<b>適航指令發布單</b> <b>Airworthiness Directive Issuance Form</b>			
民航局 AD 編號 AD number	CAA-2015-11-005C	發布日期 Date issued	2016/6/4
適用之航空產品 Applied to (models, serial numbers or part numbers, as applicable)	This AD applies to the following helicopters, when equipped with a Goodrich hoist having a Part Number (P/N) as listed in Table 1 of this AD: AW109SP, AB139, AW139 and AB412 (all Models) helicopters, all serial numbers (s/n); BHTI 212, 214 and 412 helicopters (all Models), all s/n; BHTC 429 and 430 helicopters, all s/n; AH AS 365 N3, AS 332 L2 and EC225 LP helicopters, all s/n; AHD MBB-BK117 C-2, EC135 and EC635 (all Models) helicopters, all s/n; MDHI MD900 helicopters, all s/n; and Sikorsky S-61 (all Models), S-76A, S-76B, S-76C and S-92A helicopters, all s/n.		
主旨摘要	Equipment / Furnishings - Hoist - Test / Replacement		
民航局 CAA <input type="checkbox"/> 本國產品 Native products <input type="checkbox"/> 其他個案 Other	設計國民航主管機構 Original Authorities <div style="display: flex; justify-content: space-between;"> <div> <input type="checkbox"/> FAA  <input checked="" type="checkbox"/> EASA  <input type="checkbox"/> Brazil  <input type="checkbox"/> Transport Canada Civil Aviation  <input type="check

Figure 1

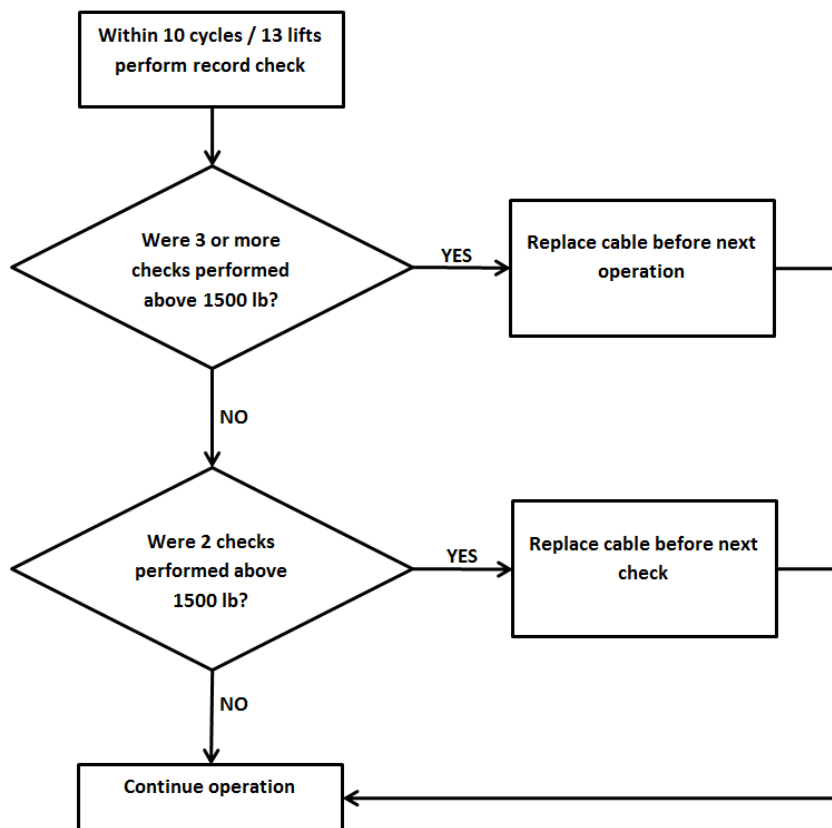
- (1) Within 10 hoist operating cycles or 13 hoist lifts (as applicable, see Note 1 of this AD) after 21 November 2015 [the effective date of the original issue of this AD], determine the P/N of the hoist installed on the helicopter and, if a Goodrich hoist is installed with a P/N listed in Table 1 of this AD, accomplish a records check to determine whether, during any previous hoist load check/test, a cable was load-tested (average of 5 pulls) at 1 500 lb [680 kg] or more. If any cable is identified to have exceeded this limit during three or more hoist load checks/tests, before next hoist operation, replace the affected cable with a serviceable cable. If any cable is identified to have exceeded this limit during two hoist load checks/tests, before the next hoist load check/test, replace the affected cable with a serviceable cable. For replacement of a cable, see figure 1 (flowchart) of this AD.
